TRANS/WP.29/GRSP/30
1 March 2002

Working Party on Passive Safety (GRSP)

**REPORT OF THE WORKING PARTY ON PASSIVE SAFETY (GRSP)
ON ITS THIRTIETH SESSION**

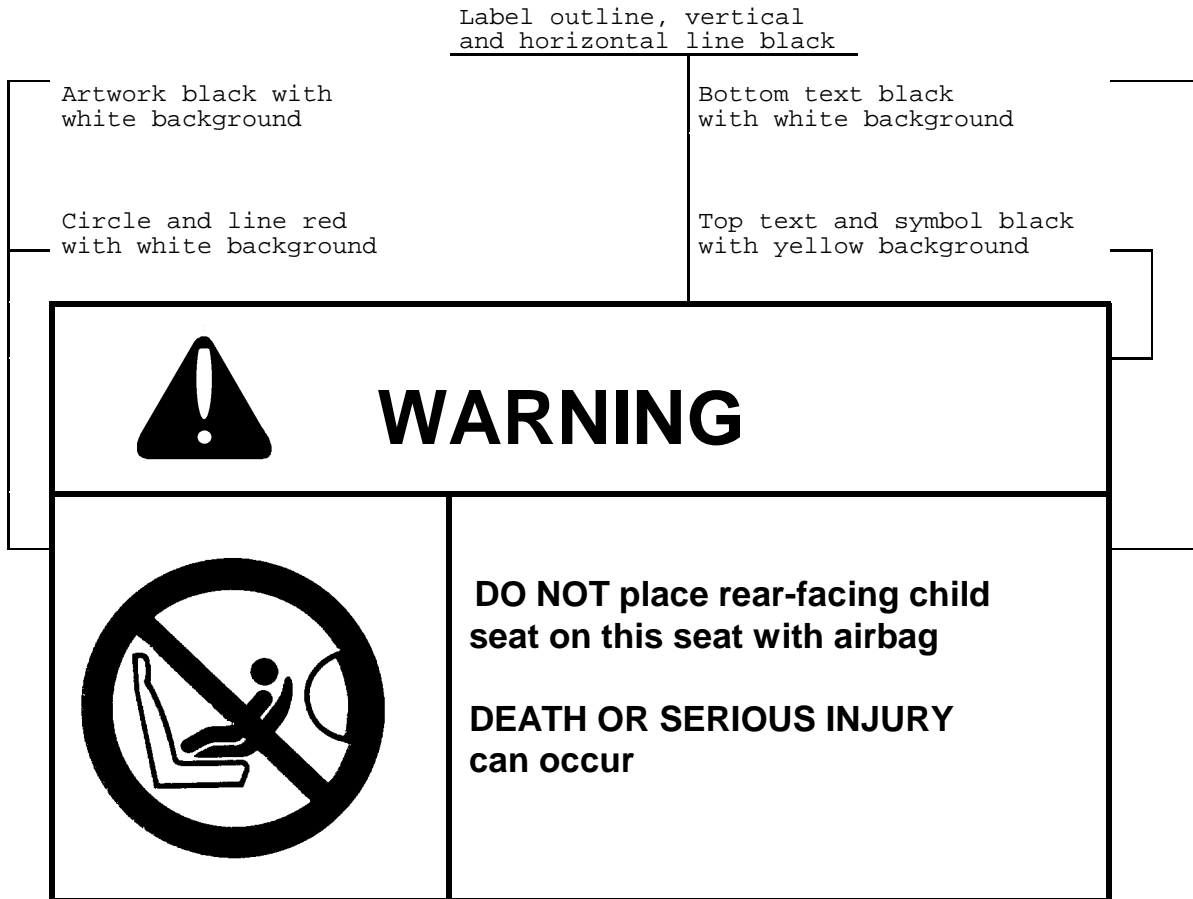
- 6.2.1. As a minimum, this information shall consist of a label containing a pictogram and text warning as indicated below.

The overall dimensions shall be 120 x 60 mm or the equivalent area, as a minimum.

The label shown above may be adapted in such a way that the layout differs from the example above; however, the text content shall meet the above prescriptions.
